**LISMORE CITY COUNCIL MINUTES PRE-LODGEEMENT MEETING**  
**Held on Wednesday, 6 September 2023**  
**82.2023.29.1**

To undertake the demolition of the existing buildings and the construction of a new residential flat building (20 Units) to be utilised as a mix of affordable housing (9 units), social housing (9 units) and Specialist Disability Assistance Units (2 units).

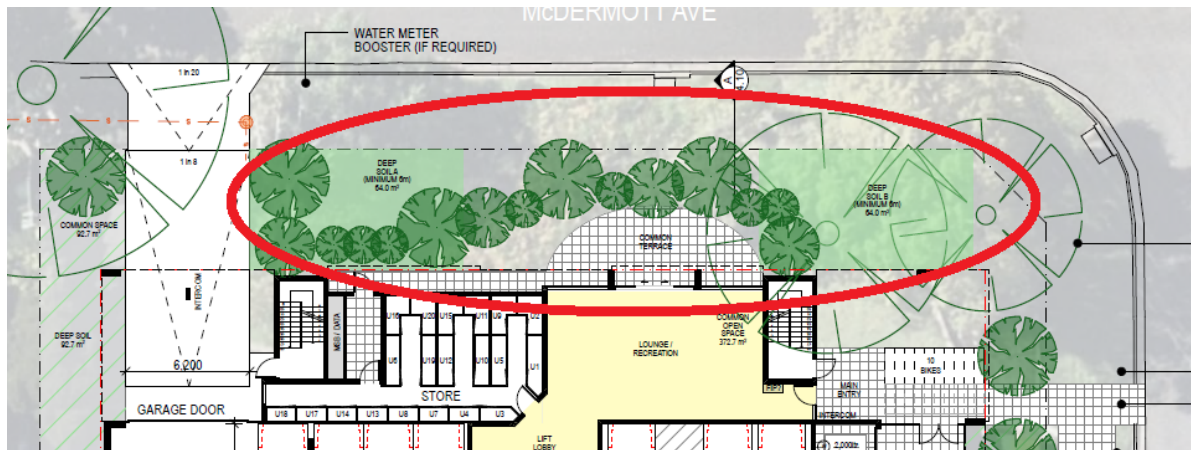
All ground-level private open space areas have been located on the southern side of the proposed building. The site constraints that led to this are understood. However, the height of the building (even with slope considered) make it unlikely that any of the ground-level private open space areas will receive adequate sunlight.

To off-set this, it is suggested that solar opportunity is maximised for those apartments that are positioned to receive sunlight. There is opportunity to improve the sizing of balconies along the northern-face of the building (units 1, 2, 9, 10, 11, 12, 19, 20), to ensure each

enjoys a large outdoor area. The balconies to the east are more difficult (units 3, 4, 13, 14), but can be re-worked to some degree, with passive surveillance of the street being a rationale to make such changes.

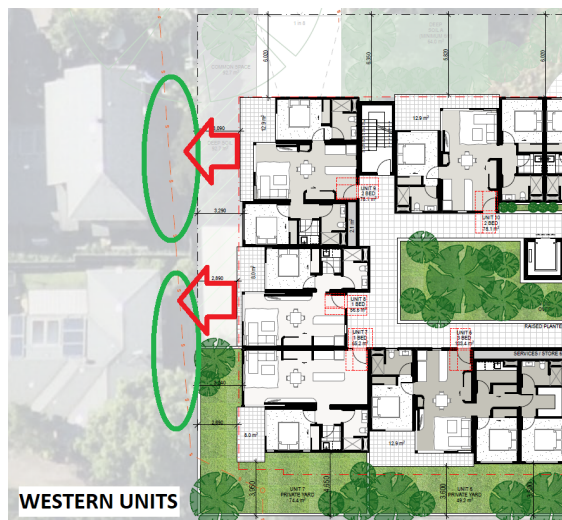
The central courtyard includes a large planter box with a deep soils base. This has the potential to be a significant maintenance issues into the future. The larger trees and significant landscaping is not likely to flourish in a planter box with limited sunlight. Concern is raised regarding the long-term maintenance of this landscaping, especially given the

development is intended to be a social housing project. Waterproofing is also likely to prove difficult, and there is a reasonable chance of leaking into the carpark in the years post-construction. Lastly, the additional weight may be costly from a construction perspective, however budget is of course your prerogative.

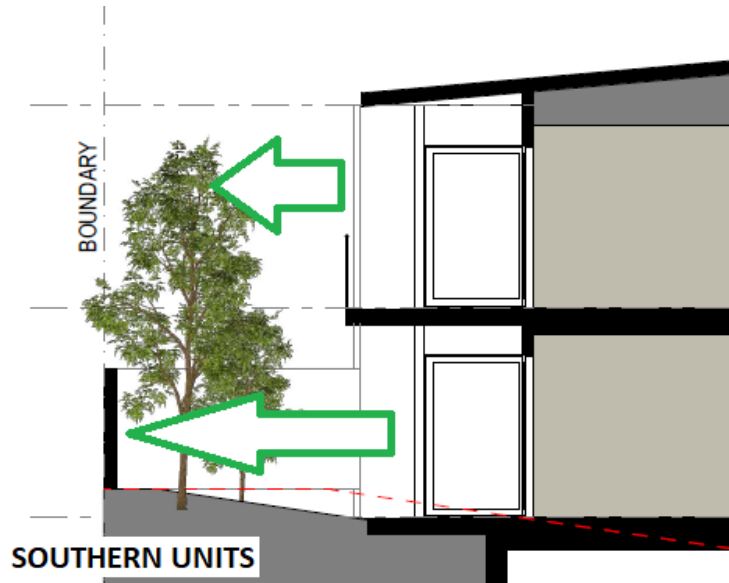
- The neighbours to the west have their private open space positioned in thin backyards along the common boundary. The proposed development is within the recommended setbacks/separation, and is raised about a half-storey above the neighbour (above screening fences), with balconies positioned into this space. Providing further separation could assist, but it is understood there is little room to move if the desired yields are to be achieved. This has the potential for conflict, and needs to be addressed.

- The neighbour to the south has private open space behind their dwelling, along the common boundary but also extending further south within their own lot. Given the gradient and northern down-slope of the subject site, the erection of the screen fencing and plantings (as shown on your cross section) is likely to resolve the issue, without impacting too significantly upon the neighbours solar access.
